Subject: Docket Number 07-03098  
Shaw AREVA MOX Services  
Mixed Oxide Fuel Fabrication Facility  
Submission of Revision 10 of the MOX Project Quality Assurance Plan

**MOX Project Quality Assurance Plan, Revision 10**

**Revision 10** was initiated to revise and update organization names and responsibilities to reflect the current MOX Project Organization.

**Figure 1-1: MOX Services Functional Organization**

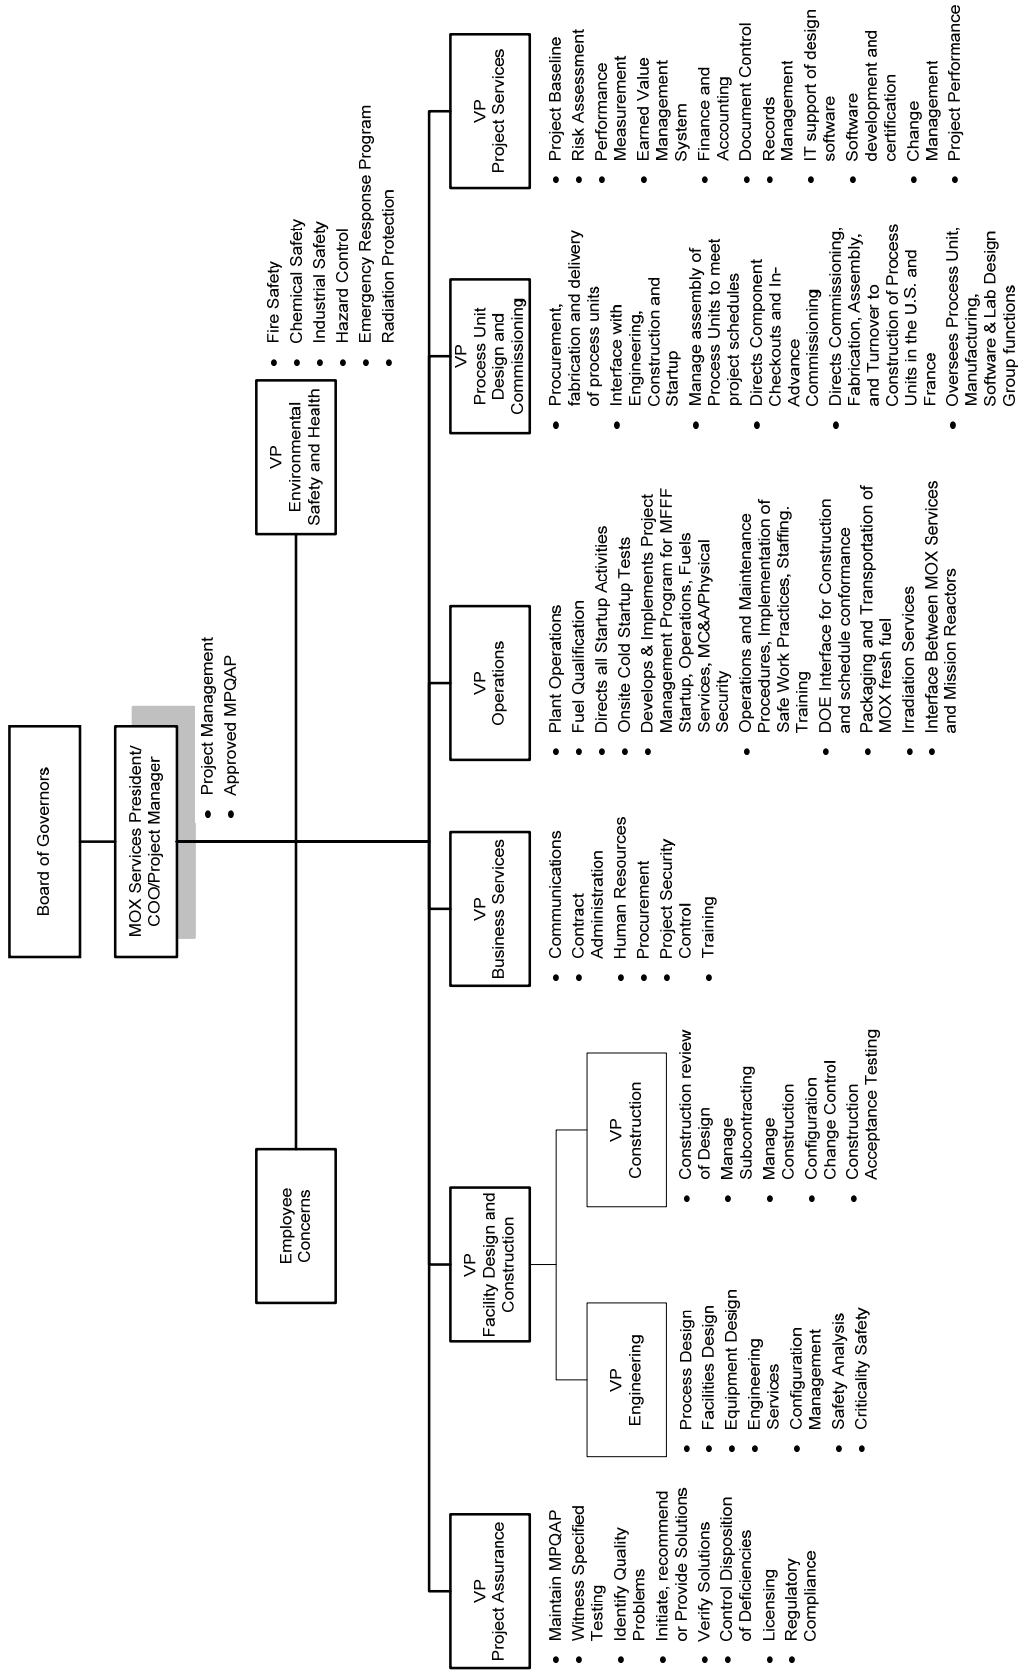
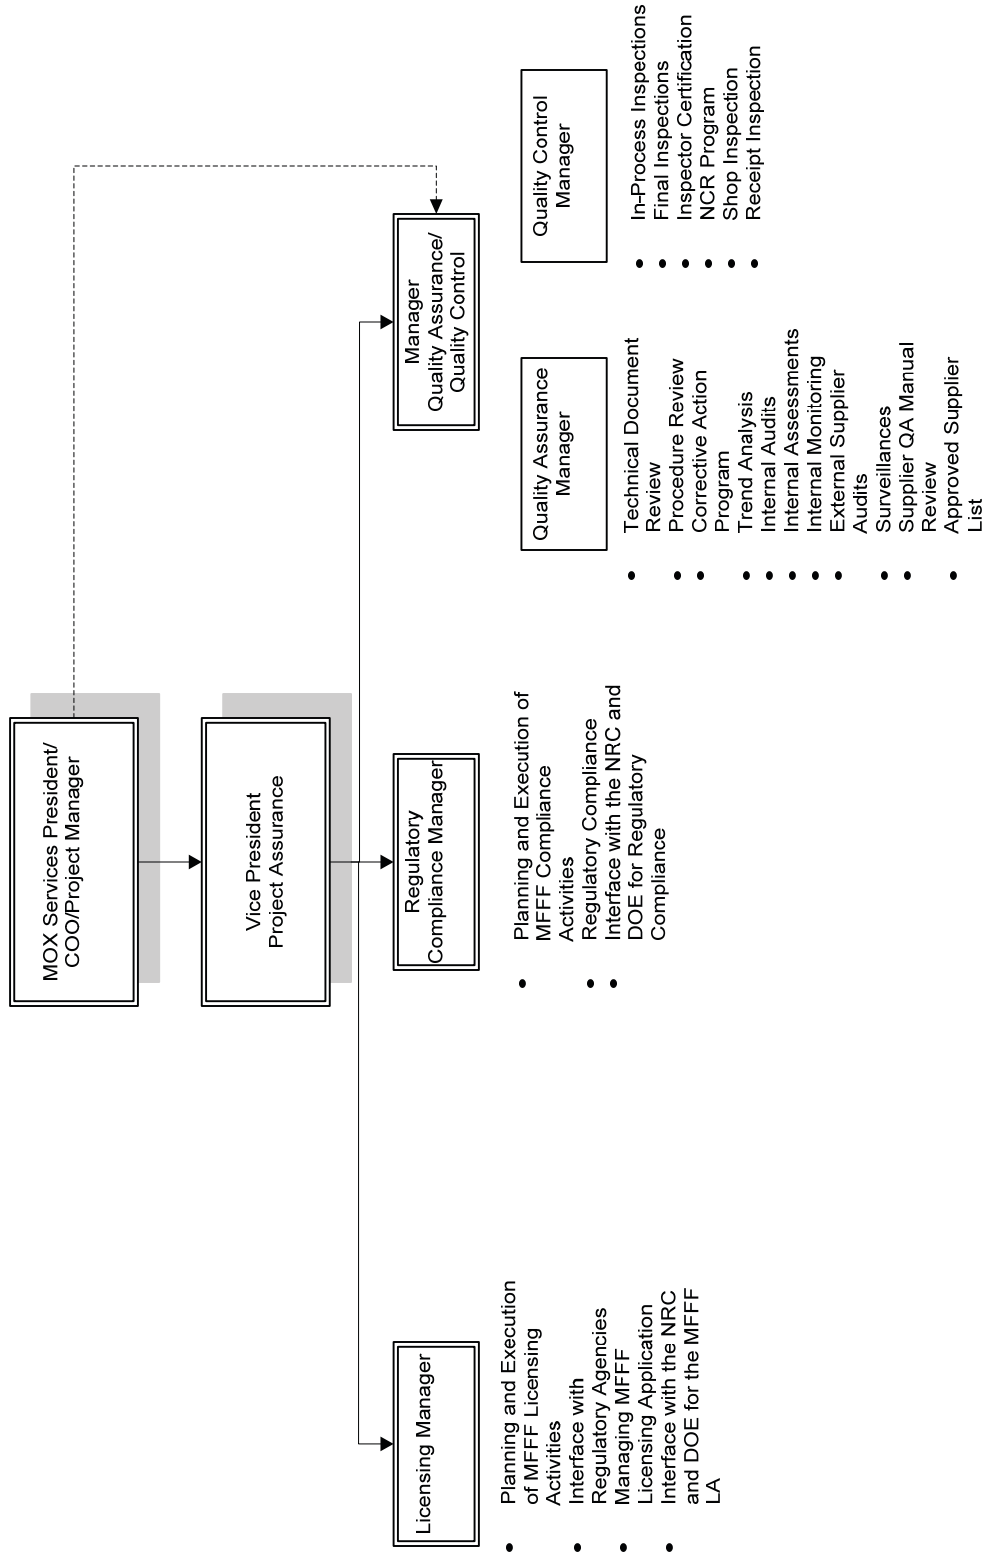
| MPQAP SECTION                      | DESCRIPTION OF CHANGE IN REVISION 10  |
|------------------------------------|---|
| Section 1                          | <ul style="list-style-type: none"> <li>Changed “Manager Project Assurance” to “VP Project Assurance” in several places and changed “Manager ES&amp;H” to “VP ES&amp;H”. Changed the Organizational charts to reflect the change in titles.</li> <li>Section 1.2.2, Fourth paragraph – added that the QA/QC Manager has direct access to the Project Manager.</li> </ul>   |
